PRODUCT/PROCESS CHANGE NOTICE (PCN)

PCN #: **TB1110-06** DATE: **11/16/2011**
 Product Affected: **10 mm x 10 mm TQFP-44**
10 mm x 10 mm TQFP-64
 Date Effective: **2/16/2012**

ATTACHMENT I - PCN #: TB1110-06

New Shipping Tray - Top Tray

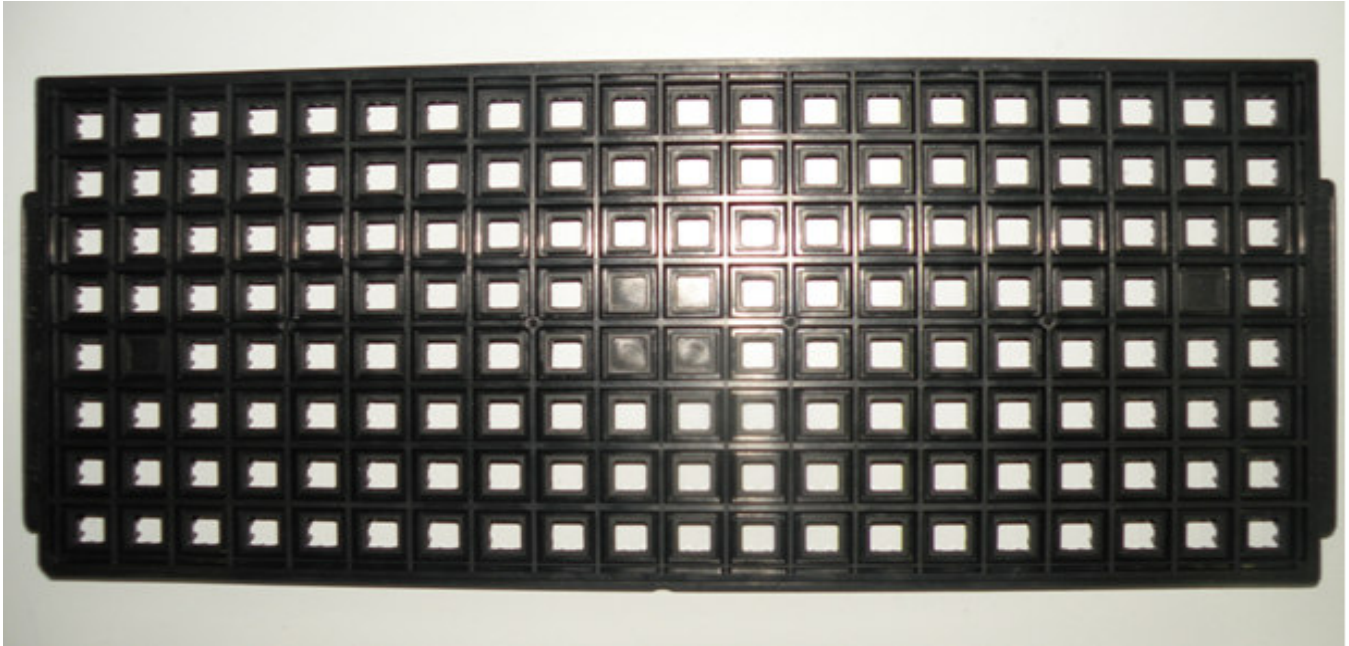
There will be changes in the tray dimensions however Qty per tray remains unchanged. Refer to Table 1.

Description	Existing Shipping Tray	New Shipping Tray
Supplier	PEAK	E-PAK
Supplier Part Number	ND 1010 1.0 0820 6 REV B	eND 1010 1.0 0820 13 R.B
Tray Matrix	8 X 20	8 X 20
Qty per Tray	160 units	160 units
Rating Temperature	150°C	140°C
Tray Material	PP6	ep13
Pocket Size (Width x Length)	9.95 X 9.95 +/- 0.05 mm	9.95 X 9.95 +/- 0.13 mm
Pocket Size (Depth)	1.87 mm	1.87 mm
Row Pitch	15.70 mm	15.70 mm
Column Pitch	15.20 mm	15.20 mm
